DEPARTMENT OF TRANSPORTATION

Quality Assurance and Source Inspection

Contract #: 04-0120F4Cty: SF/ALA Rte: 80 PM: 13.2/13.9File #: 69.28**WELDING INSPECTION REPORT****Resident Engineer:** Siegenthaler, Peter**Address:** 333 Burma Road**City:** Oakland, CA 94607**Report No:** WIR-016672**Date Inspected:** 31-Aug-2010**Project Name:** SAS Superstructure**OSM Arrival Time:** 700**Prime Contractor:** American Bridge/Fluor Enterprises, a JV**OSM Departure Time:** 1900**Contractor:** Zhenhua Port Machinery Company, Ltd (ZPMC), Changxing Island **Location:** Shanghai, China**CWI Name:** Zhao Chen Sun**CWI Present:** Yes No**Inspected CWI report:** Yes No N/A**Rod Oven in Use:** Yes No N/A**Electrode to specification:** Yes No N/A**Weld Procedures Followed:** Yes No N/A**Qualified Welders:** Yes No N/A**Verified Joint Fit-up:** Yes No N/A**Approved Drawings:** Yes No N/A**Approved WPS:** Yes No N/A**Delayed / Cancelled:** Yes No N/A**Bridge No:** 34-0006**Component:** Tower Components**Summary of Items Observed:**

For further information see below pictures:-

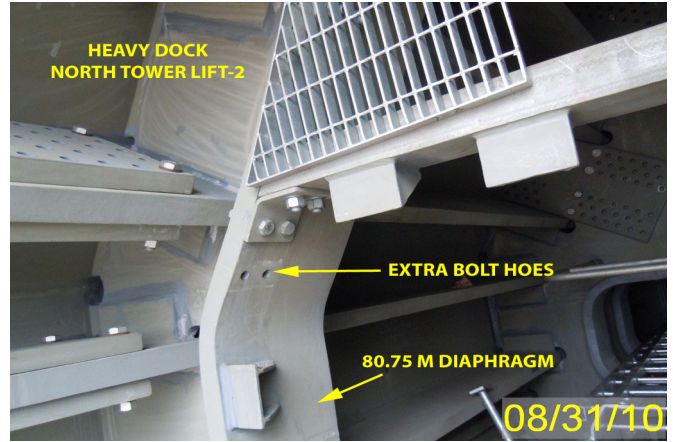
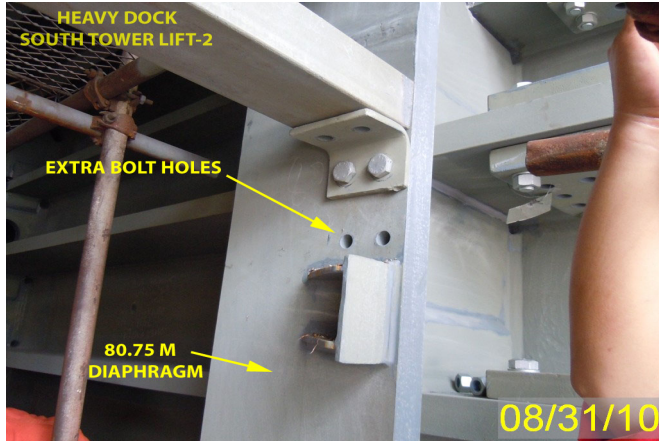
During Bolting Tension Verification in South and North Tower of Lift 2, this Caltrans Quality Assurance (QA) Inspector discovered the following issues:

- Four (4) additional bolt holes at 80.75 M single diaphragm in South Tower Lift-2.
- Four (4) additional bolt holes at 80.75 M single diaphragm in North Tower Lift-2.
- These Tower shafts are located at Heavy Dock.

Approved Drawing Sheet #SSD1-SA362 (typical)
